April 21, 2020

RE: WAP-20-01/WRG-20-01/MIS-20-01/LLA-20-01

Please accept this letter and the accompanying materials as our complete response to the City's February 5, 2020 determination that our application was incomplete (see Attachment J). We believe the materials provided herein fully respond to the incompleteness items outlined in the City's letter and provide the necessary basis to deem the application complete. We look forward to continuing to work with City staff on any design and associated issues, as necessary, during the review and approval process.

PRELIMINARY PLA PLAN WITH BUILDING SETBACKS

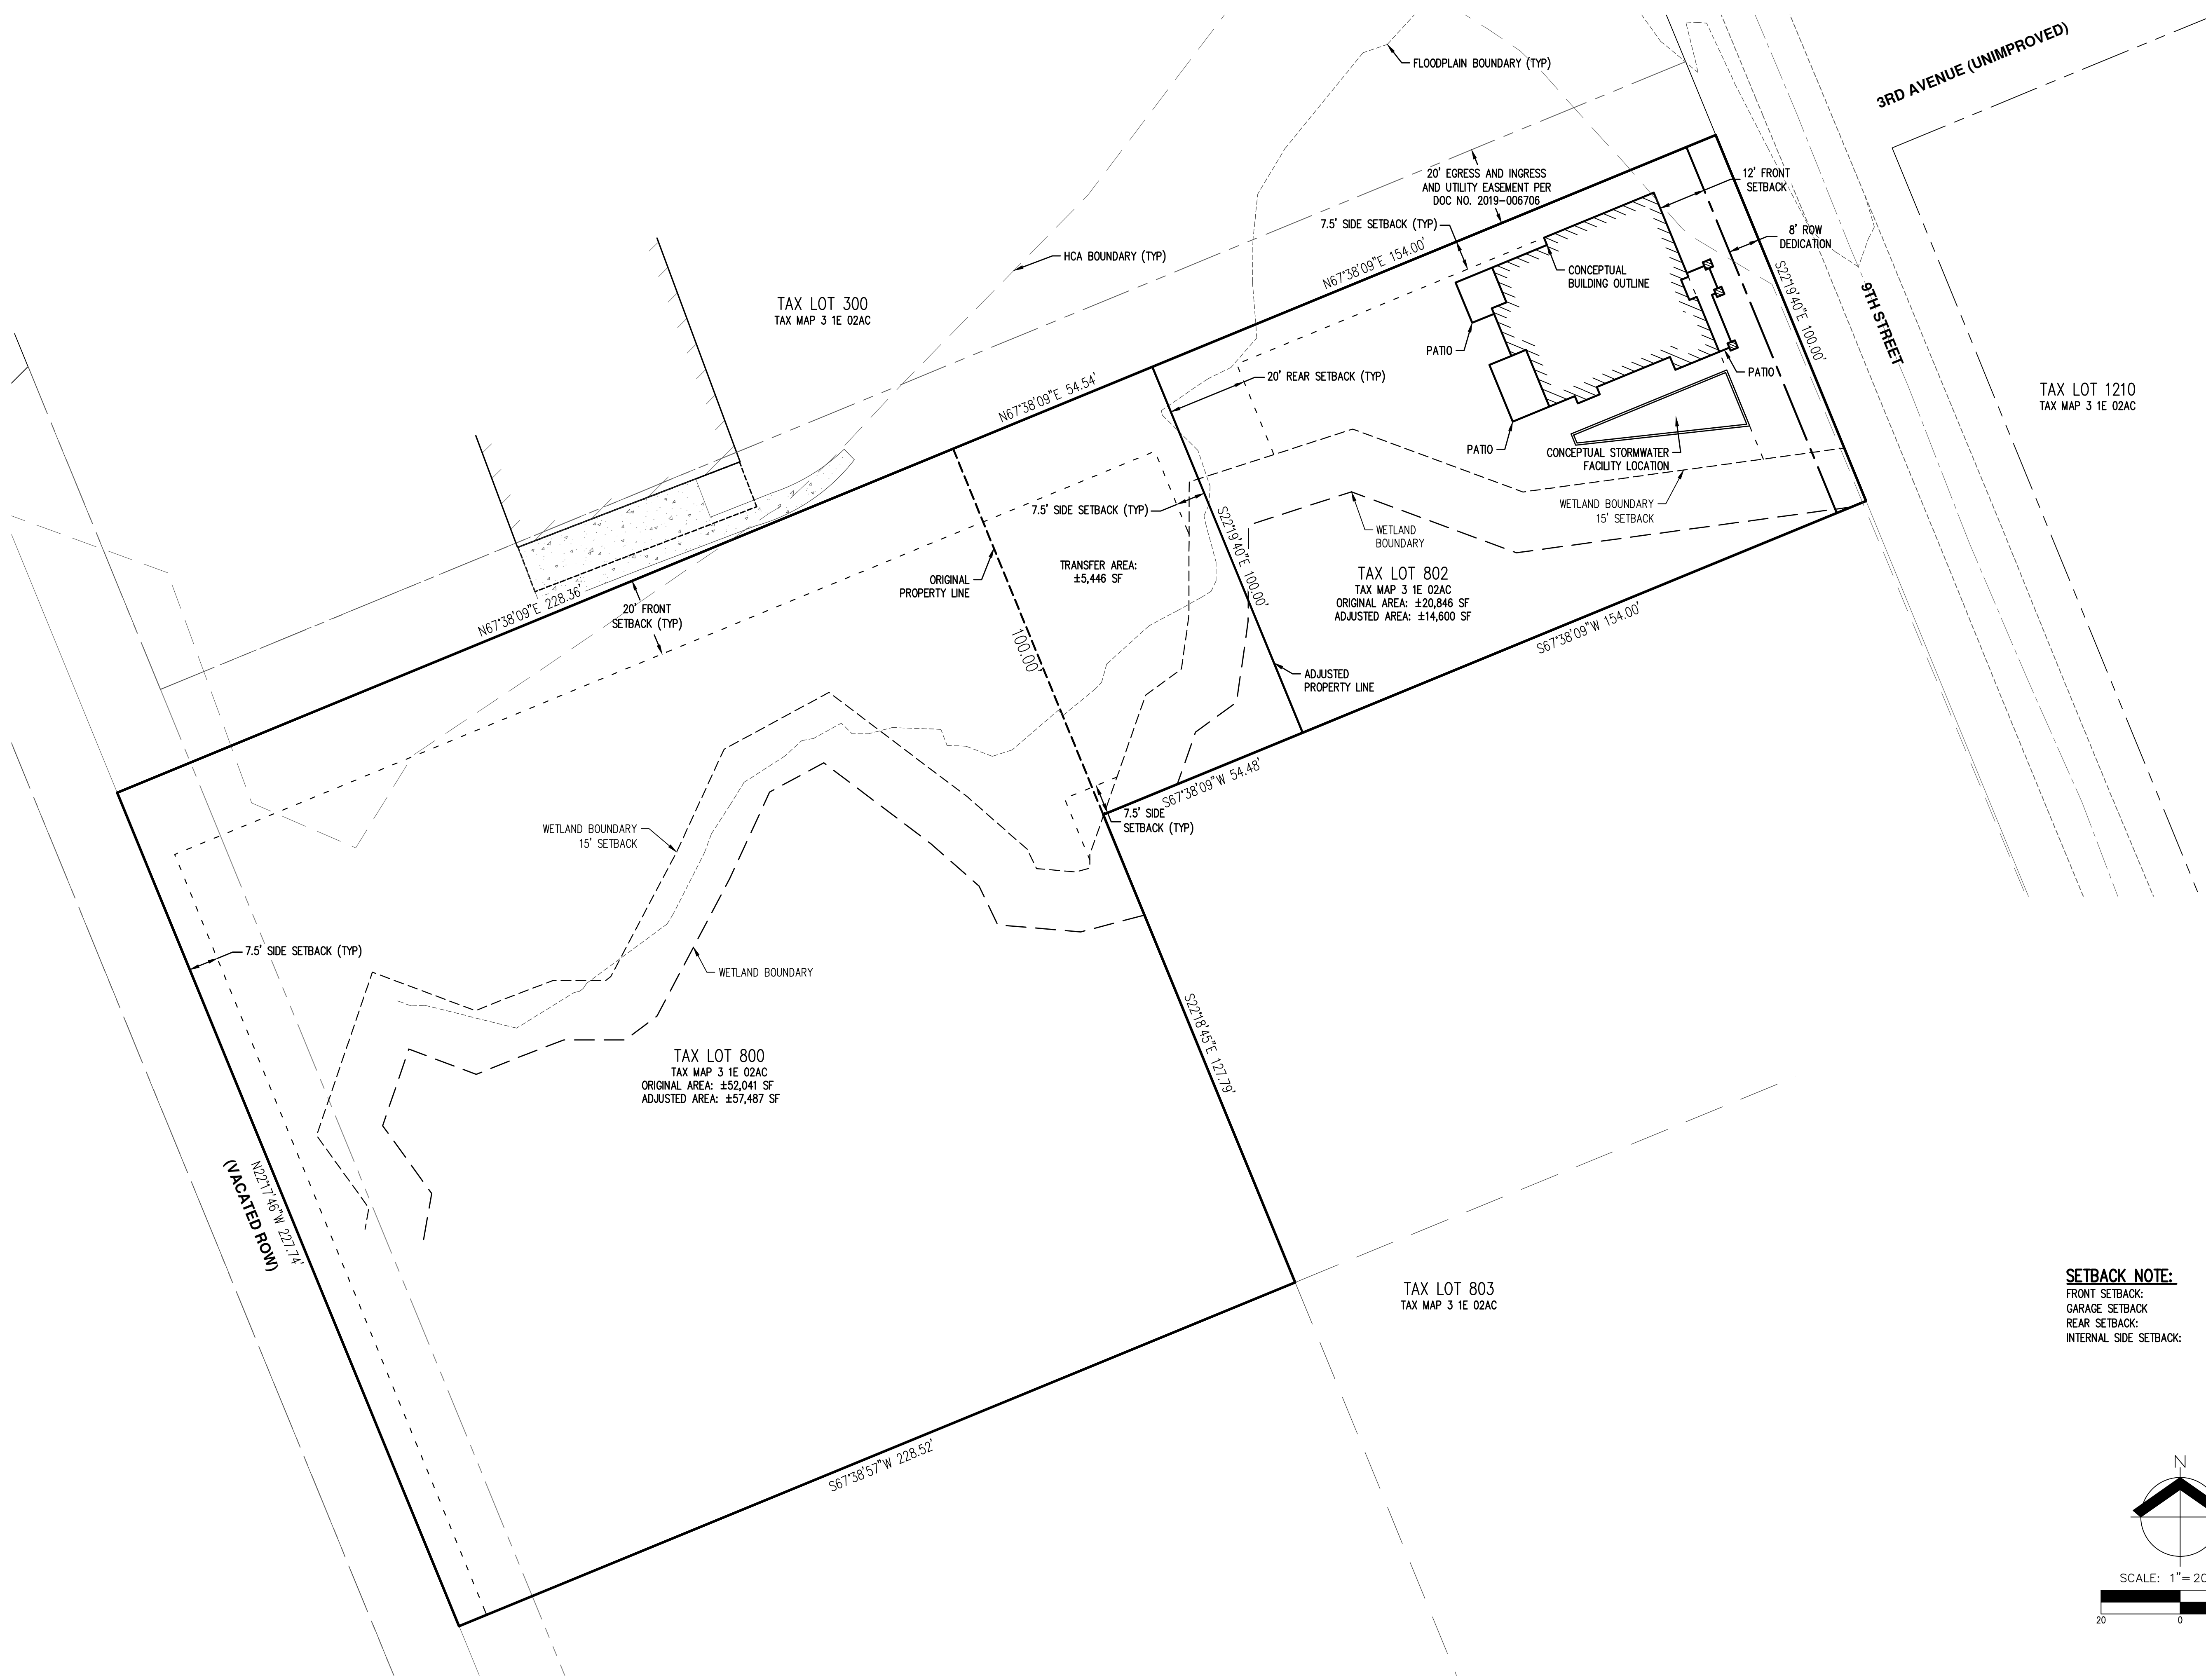
7. CDC Chapter 28.090.C(1) – Written Responses. Please provide additional findings for all criteria in 28.110 that directly respond to the criteria. For example 28.110.B(4): provide calculations of impervious surfaces and explain how this proposal is disturbing the minimum amount of HCA necessary when there are reduced setbacks that can be applied.

Response: Attachment C includes revised Preliminary Plans which show the conceptual building outline at the 7.5-foot side setback. The subject property only has HCA land available for future development, so the building envelope was moved north, further from the wetland boundary. The Applicant has requested approval for a reduced front setback of 12 feet to reduce the impacts of disturbance to the HCA.

PRELIMINARY DEMOLITION AND GRADING PLAN

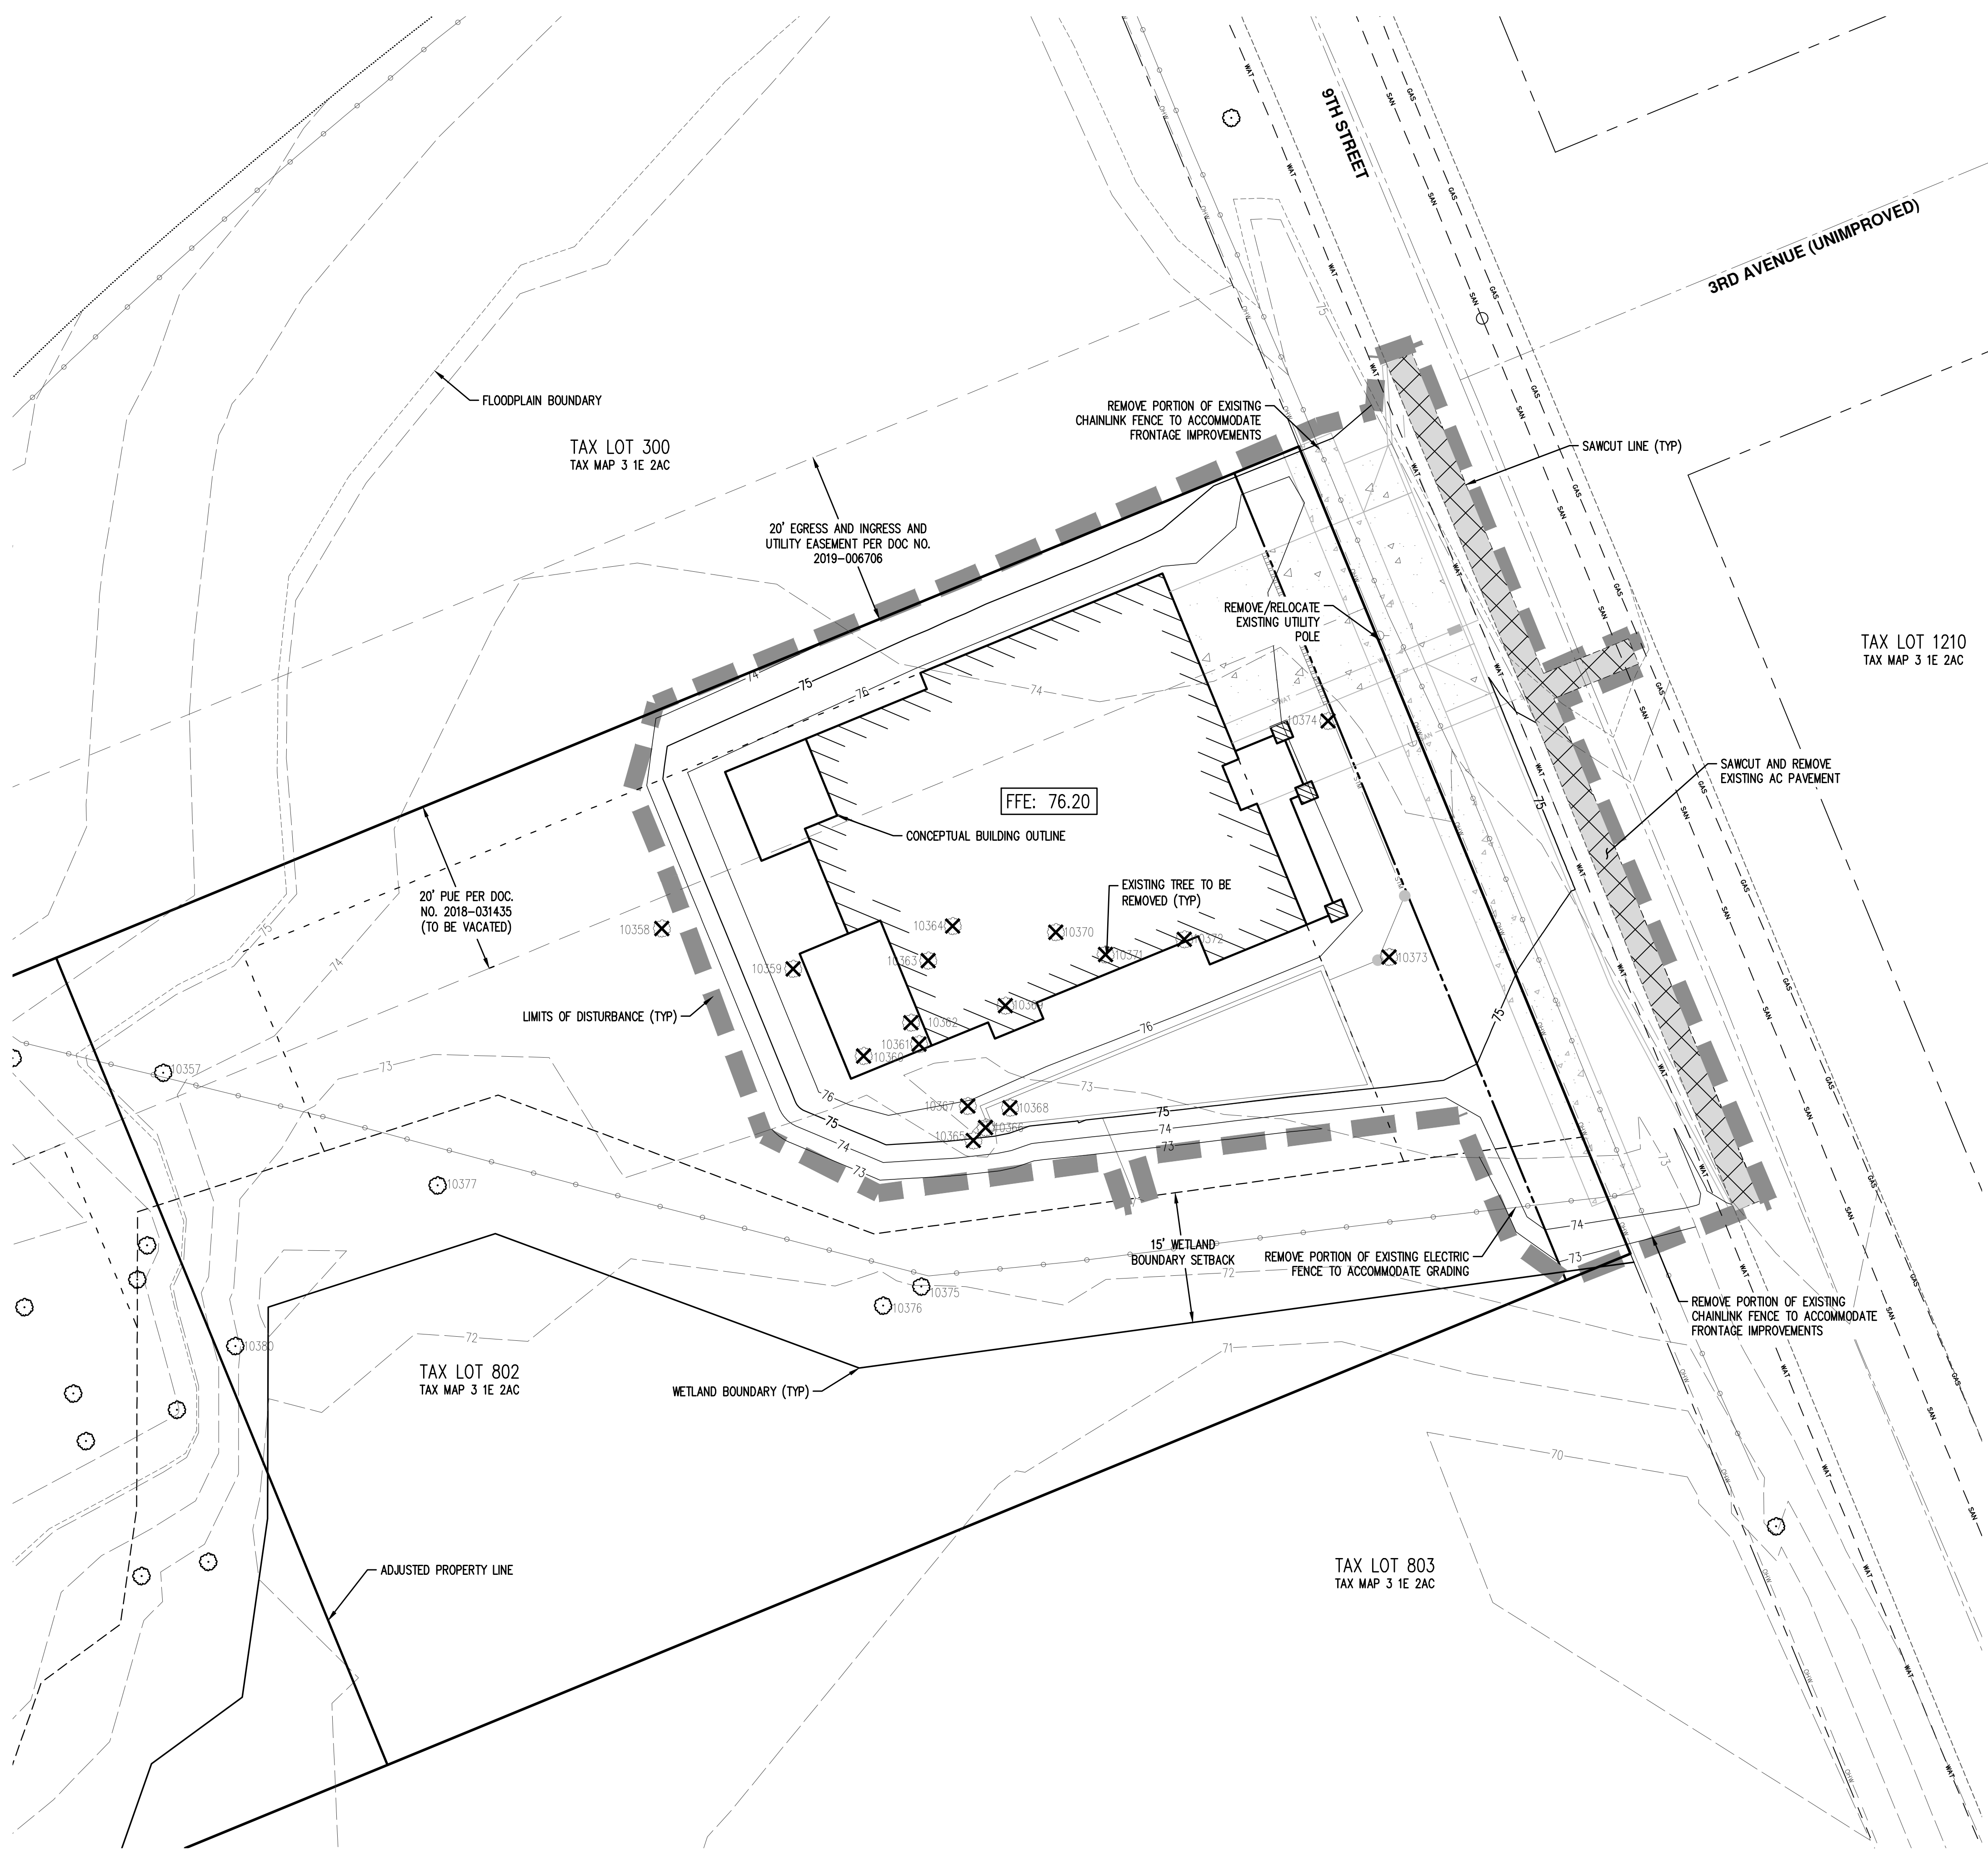
5. CDC Chapter 27.050(G) – Elevation of lowest floor. Please provide an updated Sheet P04 or an explanation of the elevation of the southwest corner of the proposed structure and it being located below the 100-year flood elevation.

Response: An updated Sheet P04 with a finished floor elevation of 76.2 feet is included in Attachment C. This criterion is met.
